KEYSTONE ELECTRONICS CORP.

RIVET, SEMI-TUBULAR

DWG NO.

3384 - 3387

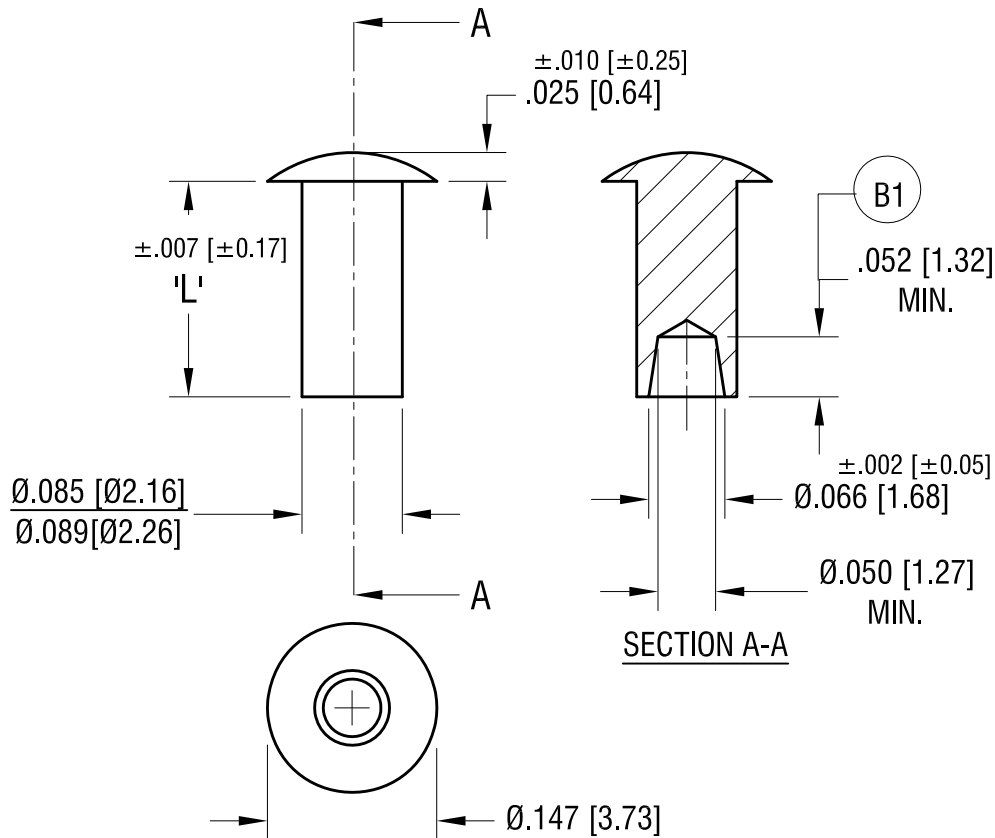
2.06.24	SWAGE HOLE IS TAPPED, WAS STANDARD (B1) WAS $.062 \pm .010$ CHANGE AS PER PCN 24-011	B
2.25.08	CHANGE AS PER ECN 08-089	A
DATE	DESCRIPTION	REV.
